UNITED STATES PATENT AND TRADEMARK OFFICE

APPLICATION NO.	FILING DATE	FIRST NAMED INVENTOR	ATTORNEY DOCKET NO.	CONFIRMATION NO.
09/748,281	12/27/2000	Kenneth G. Stewart III	6714/63409	4744

Office Action Summary

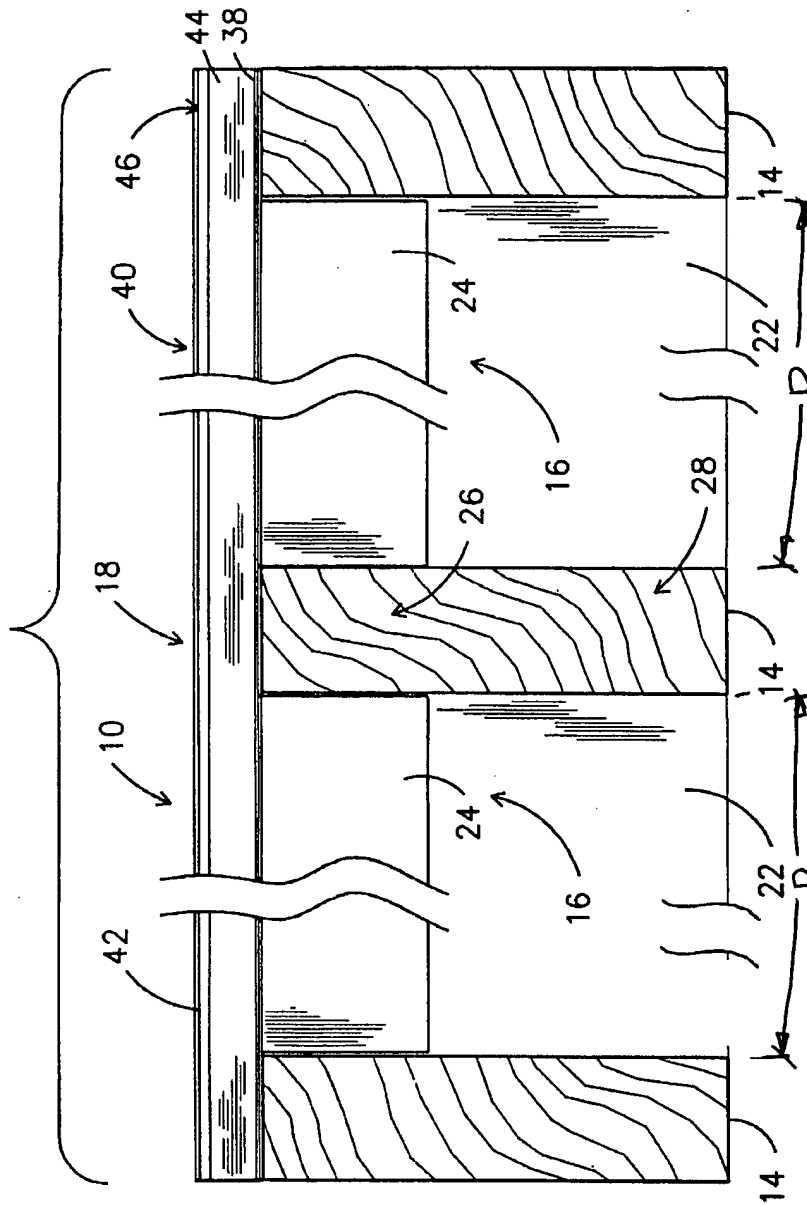
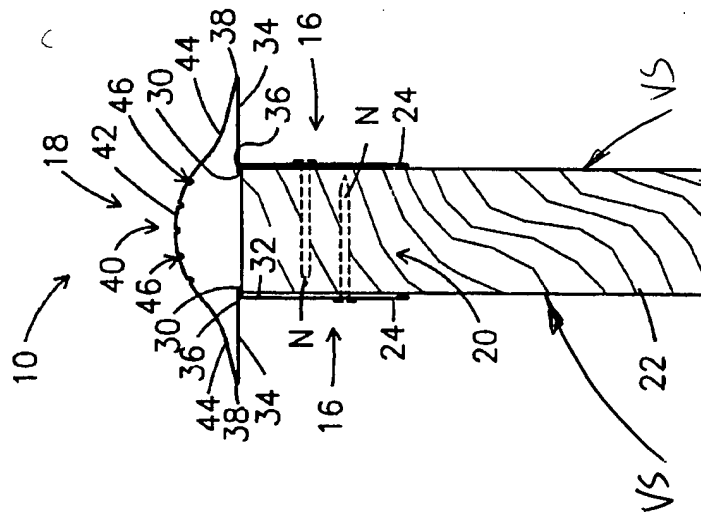
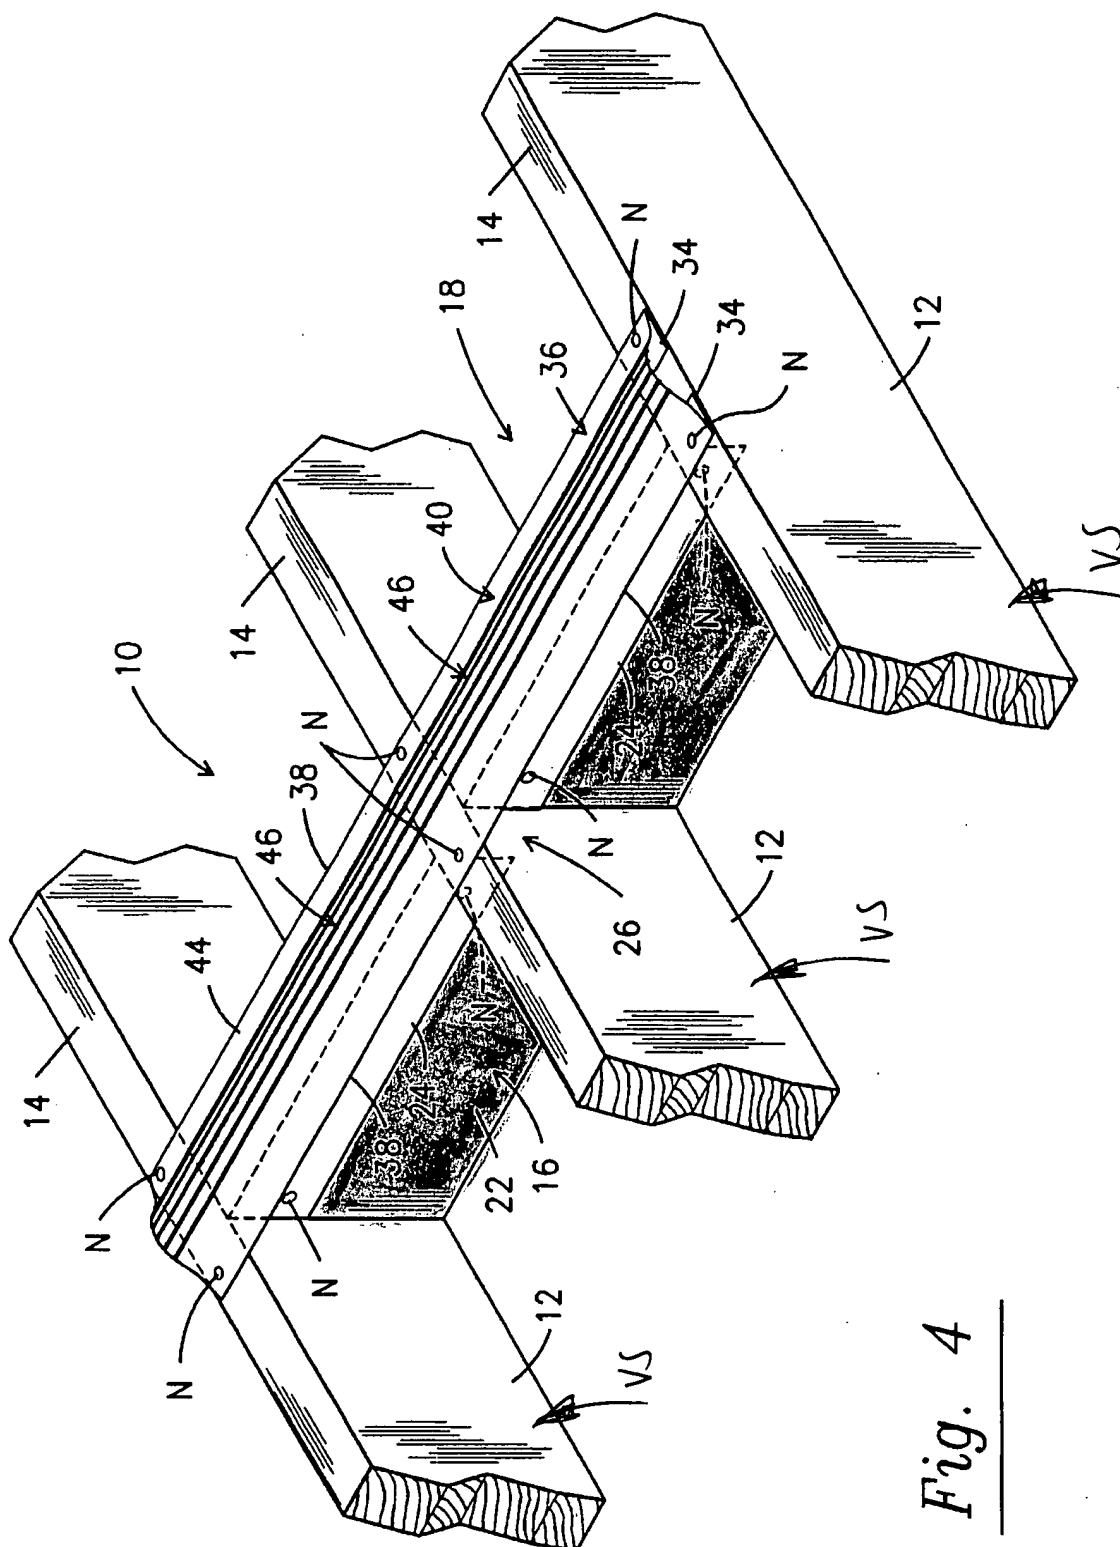
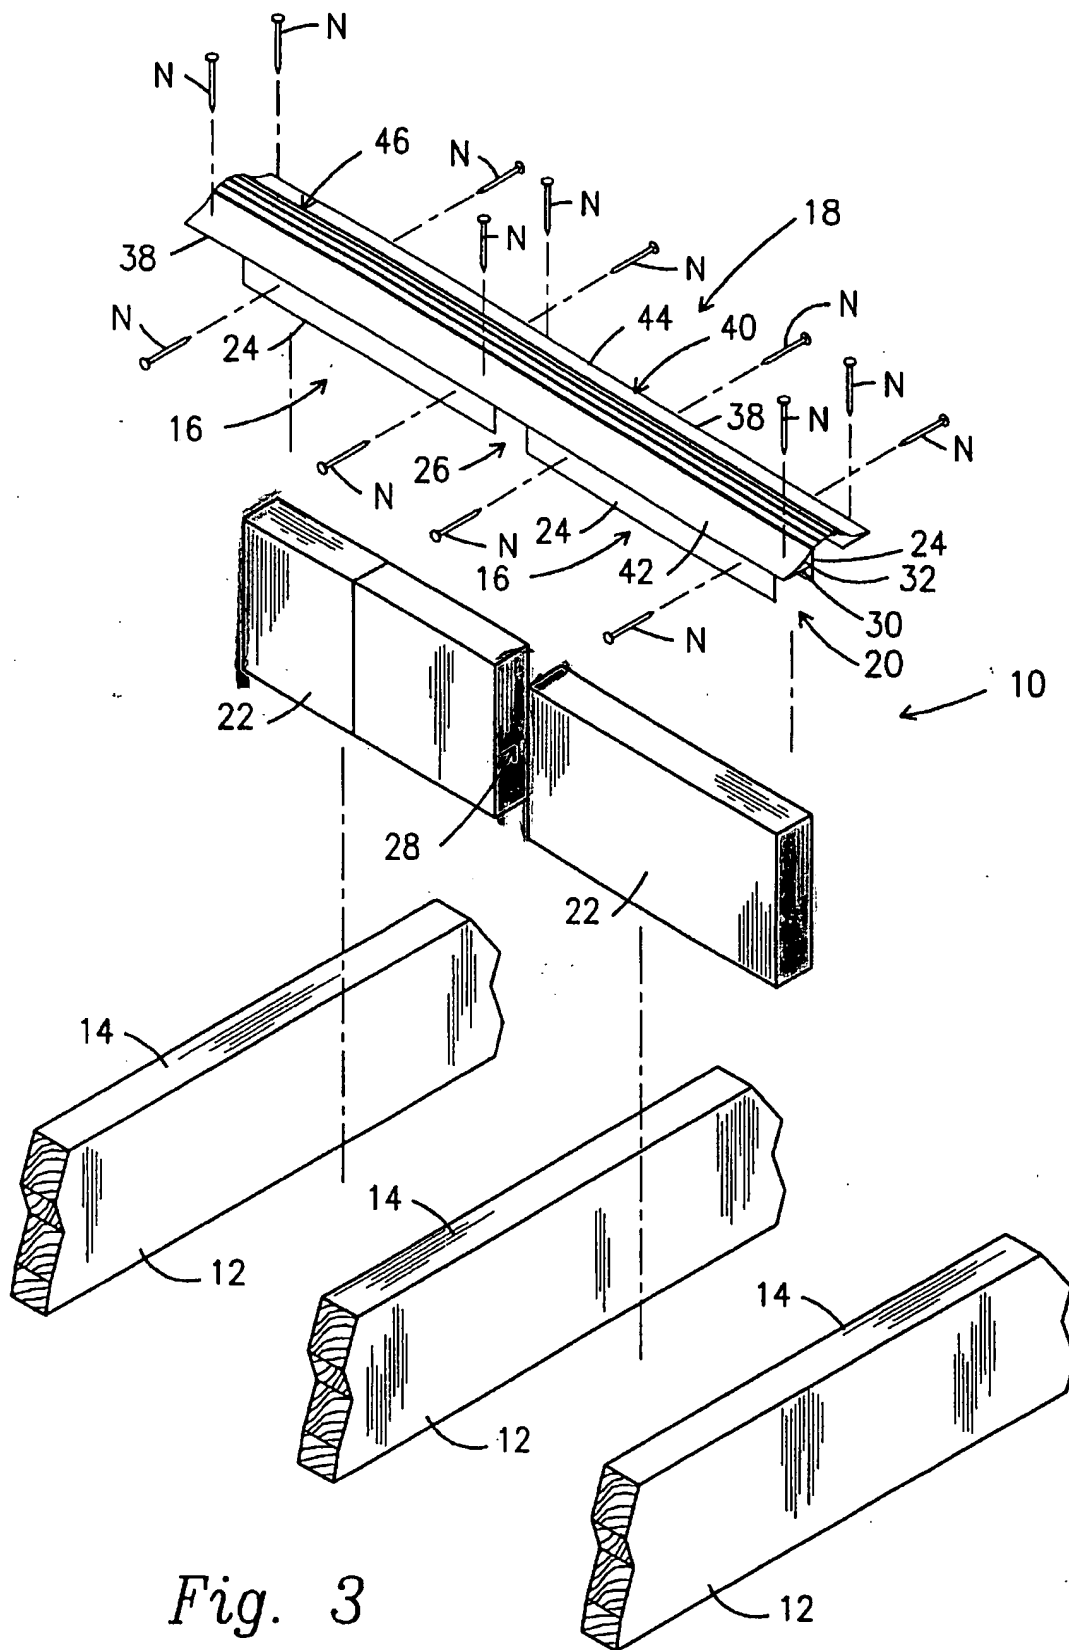
Claim 5 is rejected under 35 U.S.C. 102(b) as being anticipated by US Patent #5,551,200 to KRUG. KRUG discloses the use of a stiffening system (10) for securing adjacent joists (14) including a band (18) that spans three joists (14) and rests upon and is secured to a top surface of the at least three joists (14) as at (30,36), at least two truss members (22) configured as a rectangular box and secured to an underside of the band (18) by an adhesive, column 4, line 25, so as to lie between the joist (14) and with each truss (22) extending between two joists (14) and with the at least two truss members (22) aligned with the band (18). The at least two truss members (22) of the stiffener (18) of KRUG also includes vertical side members (colored red) equal in length

to a spacing (D) between joists (14) wherein the side members (colored red) of each truss (22) abuts the sides (VS) of the joists (14) via the interconnecting stiffener (10) to hold the joists (14) a a specified distance (D), see the marked attachment.
